**PINEHURST SUBDIVISION, BLOCK 107,**  
**RESUBDIVISION OF LOTS 15 AND 16**

Engineering Comments: FINAL PLAT COMMENTS (should be addressed prior to submitting the FINAL PLAT for review and/or signature by the City Engineer):

APPLICATION NUMBER 2 DATE March 3, 2022

# DETAIL SITE PLAN

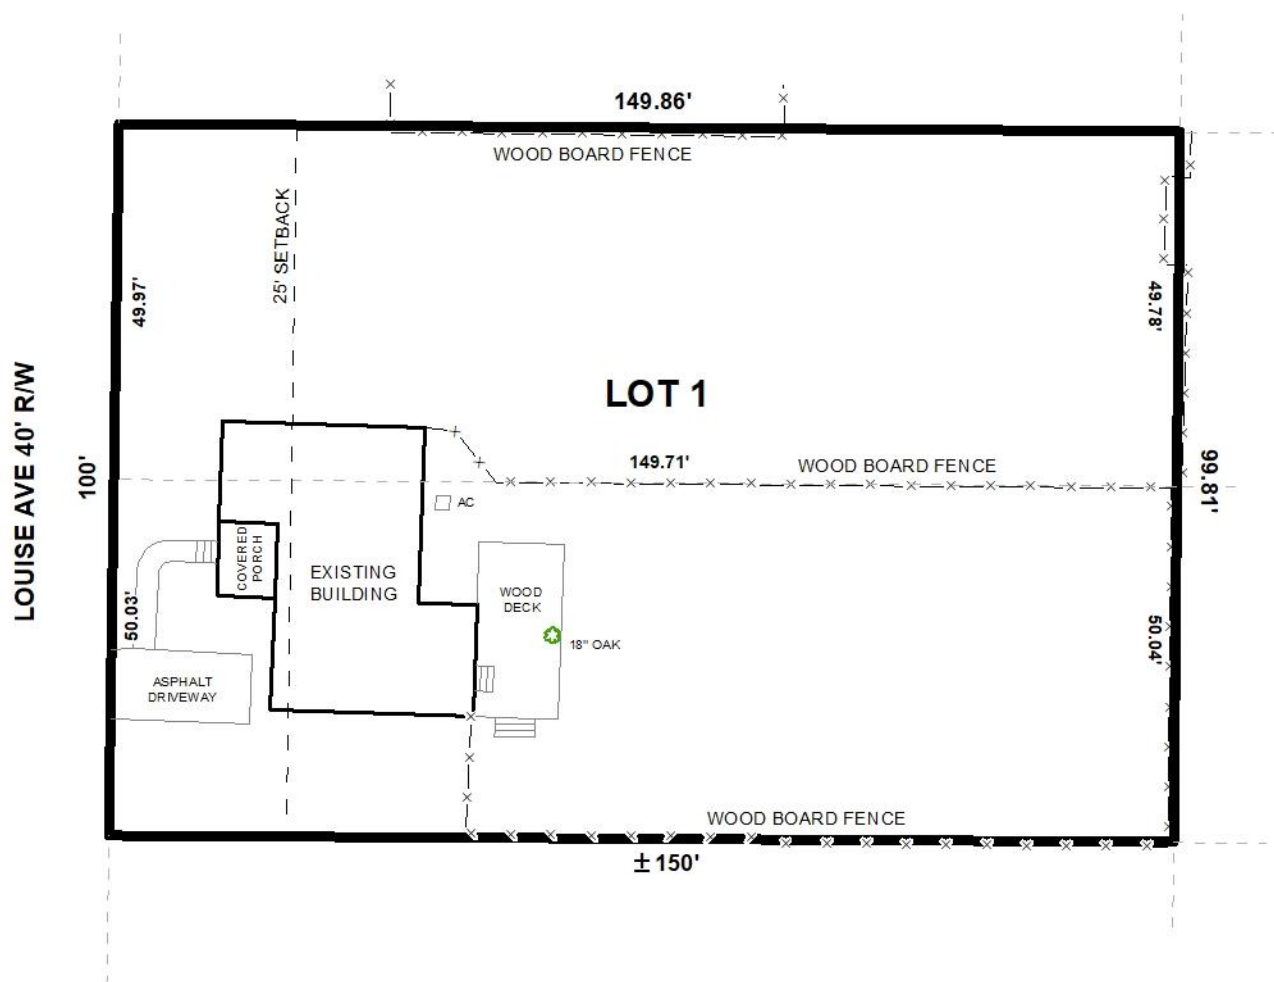
- B. Correct the information contained in GENERAL NOTE #2 – Use an actual Basis of Bearing, not “Assumed”.
- C. Correct the Legal Description to include the correct Lot Number of the existing lots.

- D. Check/verify the recording data for the existing lots.
- E. Provide a written bearing and distance for the subdivision east and south property lines.

- F. Add a note to the SUBDIVISION PLAT stating that as shown on the 1984 aerial photo (FLIGHT 19 - #75) LOT 1 will receive historical credit of existing (1984) impervious area towards stormwater detention requirement per Mobile City Code, Chapter 17, Storm Water Management and Flood Control) as follows: LOT 1 – 2,000 sf.

The proposed lot has frontage along Louise Avenue, a minor street with curbing and gutter requiring a 50-foot right-of-way. The existing right-of-way from the centerline of Louise Avenue varies between 21.9 feet and 19.9 feet, which is substandard. However, Pinehurst was platted

The proposed lot will exceed the minimum size requirements for lots served by public water and sanitary sewer systems, and it is appropriately labeled in both square feet and acres. This information should be retained on the Final Plat, if approved; or provision of a table on the Final Plat with the same information may suffice.

The 25-foot minimum building setback line is illustrated along Louise Avenue, per Section V.D.9. of the Subdivision Regulations, and should be retained on the Final Plat, if approved. It should be noted that the existing dwelling extends into the 25-foot minimum building setback and is a condition that appears to pre-date current regulations; however, a note should be placed on the Final Plat stating all future site improvements shall conform to current regulations.

- 1) Retention of the lot's size in acres and square feet on the Final Plat, or provision of a table on the Final Plat providing the same information;
- 2) Retention of the 25-foot minimum building setback line along Louise Avenue, in compliance with Section V.D.9. of the Subdivision Regulations;

- 3) Placement of a note on the Final Plat stating all future site improvements shall conform to current regulations;
- 4) Compliance with Engineering comments: (*FINAL PLAT COMMENTS (should be addressed prior to submitting the FINAL PLAT for review and/or signature by the City Engineer): A) Provide all of the required information on the SUBDIVISION PLAT (i.e. signature blocks, signatures, certification statements, written legal description, required notes, legend, scale, bearings and distances) that is required by the current Alabama State Board of Licensure for Professional Engineers and Land Surveyors. B) Correct the information contained in GENERAL NOTE #2 – Use an actual Basis of Bearing, not “Assumed”. C) Correct the Legal Description to include the correct Lot Number of the existing lots. D) Check/verify the recording data for the existing lots. E) Provide a written bearing and distance for the subdivision east and south property lines. F) Add a note to the SUBDIVISION PLAT stating that as shown on the 1984 aerial photo (FLIGHT 19 - #75) LOT 1 will receive historical credit of existing (1984) impervious area towards stormwater detention requirement per Mobile City Code, Chapter 17, Storm Water Management and Flood Control) as follows: LOT 1 – 2,000 sf. G) Email a pdf copy of the FINAL SUBDIVISION PLAT and LETTER OF DECISION to the Permitting Engineering Dept. for review at [land.disturbance@cityofmobile.org](mailto:land.disturbance@cityofmobile.org) prior to obtaining any signatures. No signatures are required on the drawing. H) After addressing all of the FINAL SUBDIVISION PLAT review comments provide the ORIGINAL (with all signatures except for the Planning Commission, Traffic Engineering, and City Engineer), one (1) copy, and a transmittal letter to the Engineering Permitting Department. They can be dropped off at 205 Government St. or mailed to PO Box 1827, Mobile, AL, 36633.*);
